UNITED STATES PATENT AND TRADEMARK OFFICE

APPLICATION NO.	FILING DATE	FIRST NAMED INVENTOR	ATTORNEY DOCKET NO.	CONFIRMATION NO.
09/581,602	08/18/2000	Manabu Oumi	S004-4005(PC)	9810
40627	7590	04/19/2007	EXAMINER	
ADAMS & WILKS 17 BATTERY PLACE SUITE 1231 NEW YORK, NY 10004			PSITOS, ARISTOTELIS M	
			ART UNIT	PAPER NUMBER
			2627	
SHORTENED STATUTORY PERIOD OF RESPONSE		MAIL DATE	DELIVERY MODE	
3 MONTHS		04/19/2007	PAPER

Office Action Summary	Application No. 09/581,602	Applicant(s) OUMI ET AL.	
	Examiner Aristotelis M. Psitos	Art Unit 2627

DETAILED ACTION

FIG. 26

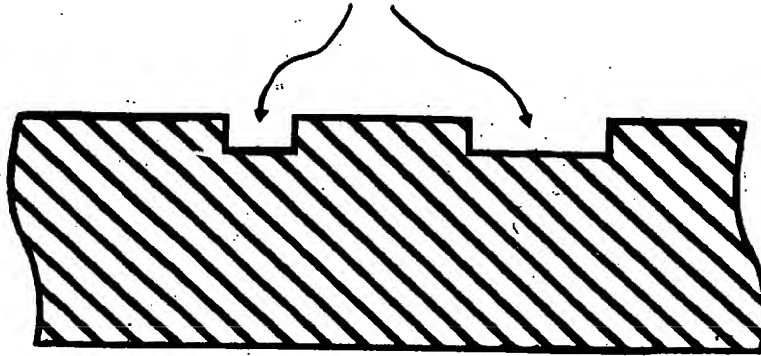
The newly submitted figures 26 and 27 have been received; however, the drawings are objected to under 37 CFR 1.83(a) because they fail to show either the groove or the optical different refractive indexes as described in the specification. Although these drawings have particular indicia indicated thereon, i.e., 1500 as in fig. 26 there is no clear indication as to what this refers to. The examiner strongly recommends labeling such indicia in both figures. Any structural detail that is essential for a proper understanding of the disclosed invention should be shown in the drawing. MPEP § 608.02(d). Corrected drawing sheets in compliance with 37 CFR 1.121(d) are required in reply to the Office action to avoid abandonment of the application. Any amended replacement-drawing sheet should include all of the figures appearing on the immediate prior version of the sheet, even if only one figure is being amended. The figure or figure number of an amended drawing should not be labeled as "amended." If a drawing figure is to be canceled, the appropriate figure must be removed from the replacement sheet, and where necessary, the remaining figures must be renumbered and appropriate changes made to the brief description of the several views of the drawings for consistency. Additional replacement sheets may be necessary to show the renumbering of the remaining figures. Each drawing sheet submitted after the filing date of an application must be labeled in the top margin as either "Replacement Sheet" or "New Sheet" pursuant to 37 CFR 1.121(d). If the examiner does not accept the changes, the applicant will be notified and informed of any required corrective action in the next Office action. The objection to the drawings will not be held in abeyance.

do not enter
